## PLAT COMMITTEE

August 13, 2025

<b>Case Number:</b>	2025-PLT-050
<b>Property Address:</b>	2031, 2033, 2035, 2041, 2047, 2051 and 2053 Ralston Avenue ( <i>Approximate Addresses</i> )
<b>Location:</b>	Center Township, Council District # 8
<b>Petitioner:</b>	Martindale Brightwood Community Development Corporation, by Donna Jo Smithers
<b>Zoning:</b>	D-8
<b>Request:</b>	Approval of a Subdivision Plat, to be known as Re-Plat Lots 150, 151, 152, 153, 155, 156 and 157 of Cooper and Picken's Second Addition, dividing 0.674-acre into 13 lots for a townhome development.
<b>Waiver Requested:</b>	None
<b>Current Land Use:</b>	Undeveloped
<b>Staff Reviewer:</b>	Jeffrey York, Manager

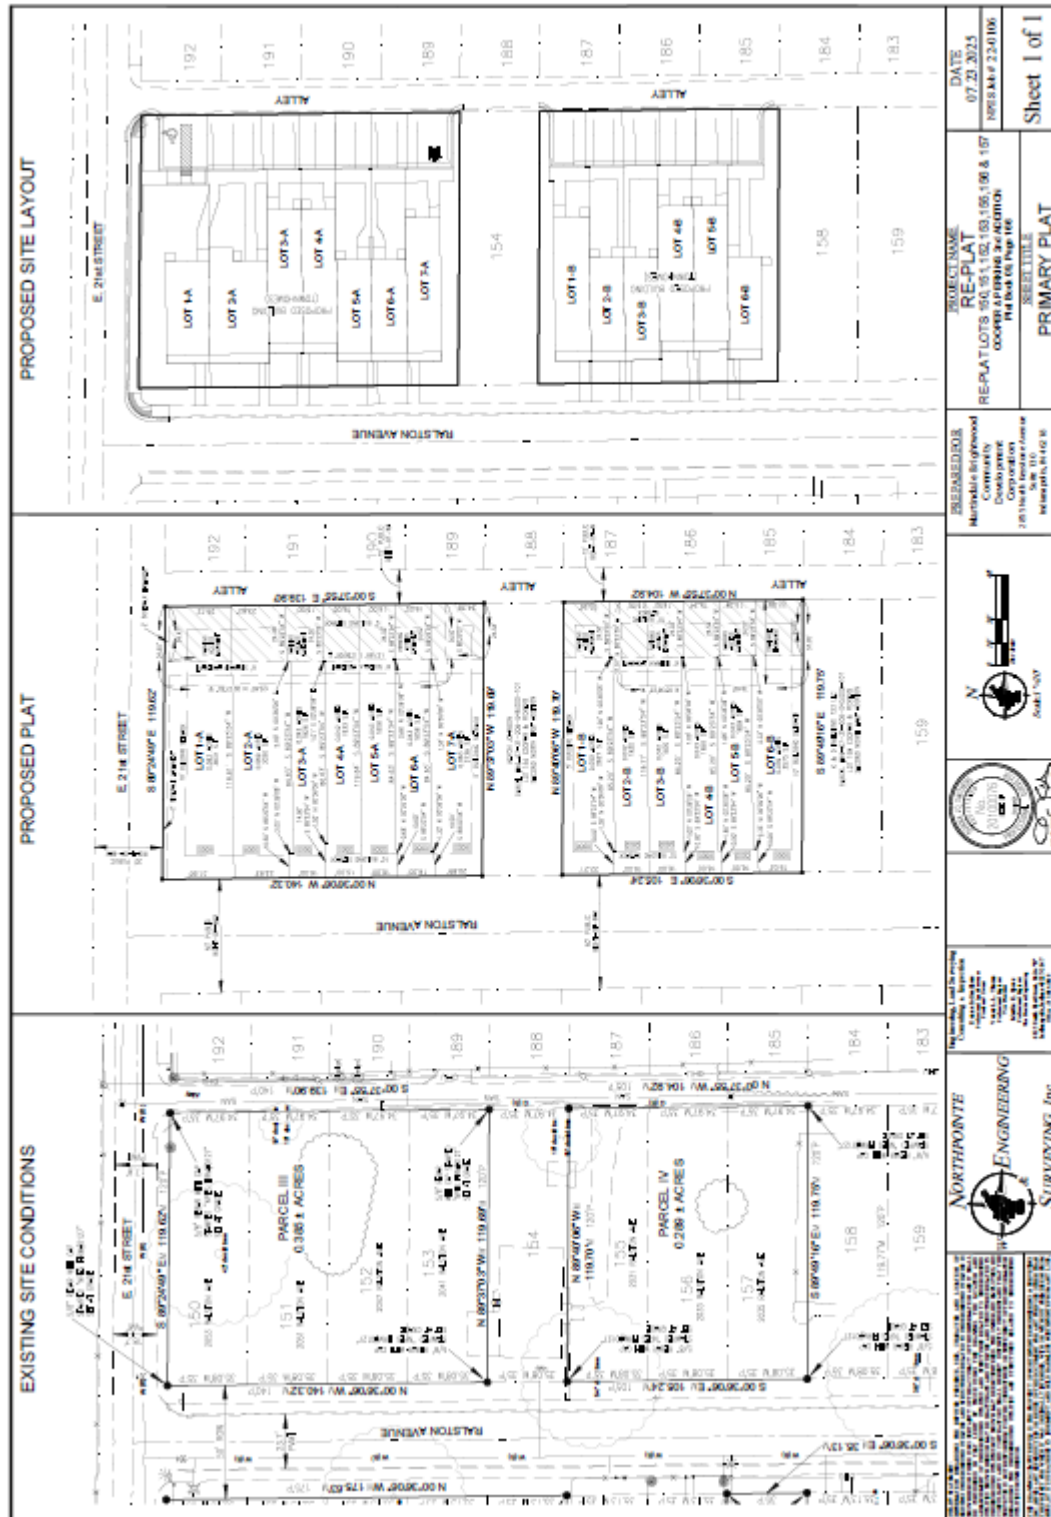
The subject site is zoned D-8 and consists of seven undeveloped lots. The subject site was platted into two blocks, via 2023-PLT-040. This proposed plat would plat the two blocks into 13 total lots, for a townhome development. The northern area, which contains 0.385-acre, would be divided into seven lots, with the remaining six lots in the southern area, which contains 0.289-acre. The proposed plat generally meets the standards of the D-8 zoning classification for a townhome development.

Both areas would front on Ralston Avenue with alley access on the rear. The northern area would also front on East 21<sup>st</sup> Street to the north. No new streets are proposed.

Sidewalks are existing on Ralston Avenue. Sidewalks are required on East 21<sup>st</sup> Street.

Staff recommends that the Plat Committee **approve** and find that the plat, file-dated July 24, 2025, complies with the standards of the Subdivision regulations, subject to the following conditions:
